Access Compliance Report

Public Rights-of-Way

Intersection ID: 45514	Main Street: MEADOW_BOTTOM_RD	Cross Street: COTTON_PRESS_RD	Location: W
ADA ID: 7B37BA599F50	Ramp Type: PerpDiag	Initial Pass/Fail: Fail	Overall Compliance: No
Severity Score: 33.75			
Codes/Mitigation Info/Possible Solution		Field Measurements/Component Compliance

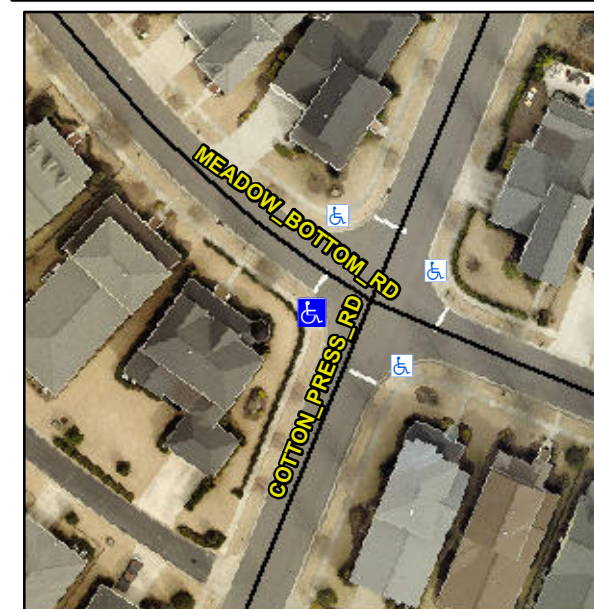
Not Found, R304.5.1, R304.2.2

Compliance	Description	Data	Compliance	Description	Data
N/A	Ramp Length (in)	75.0	No	Ramp Slope (%)	13.4
No	Ramp Width (in)	38.5	Yes	Ramp XSlope (%)	1.3
N/A	Flare Type LT	N/A	N/A	Flare Type RT	N/A
N/A	Flare Slope LT (%)	N/A	N/A	Flare Slope RT (%)	N/A
N/A	Flare Traversable LT?	N/A	N/A	Flare Traversable RT?	N/A
N/A	Landing Length (in)	N/A	N/A	DWS Provided?	N/A
N/A	Landing Width (in)	N/A	N/A	DWS Contrast?	N/A
N/A	Landing Slope (%)	N/A	N/A	DWS Length (in)	N/A
N/A	Landing X Slope (%)	N/A	N/A	DWS Full Width?	N/A
N/A	Landing Curb? (Y/N)	N/A	N/A	DWS Offset (in)	N/A
N/A	Shared Landing?	N/A			
N/A	Gutter Ponding?	N/A	N/A	Gutter Slope (%)	N/A
N/A	Gutter Lip Ht (in)	N/A	N/A	Gutter X Slope (%)	N/A
N/A	Painted X Walk1?	No	N/A	Painted X Walk2?	No
	X Walk 1 Direction	To SE		X Walk 2 Direction	To NE
N/A	X Walk 1 Width (in)	N/A	N/A	X Walk 2 Width (in)	N/A
	X Walk 1 Slope (%)	2.8		X Walk 2 Slope (%)	0.2
	X Walk 1 X Slope (%)	0.2		X Walk 2 X Slope (%)	0.9

Remove & Replace Curb Ramp With Two New Directional Ramps or Equivalent.
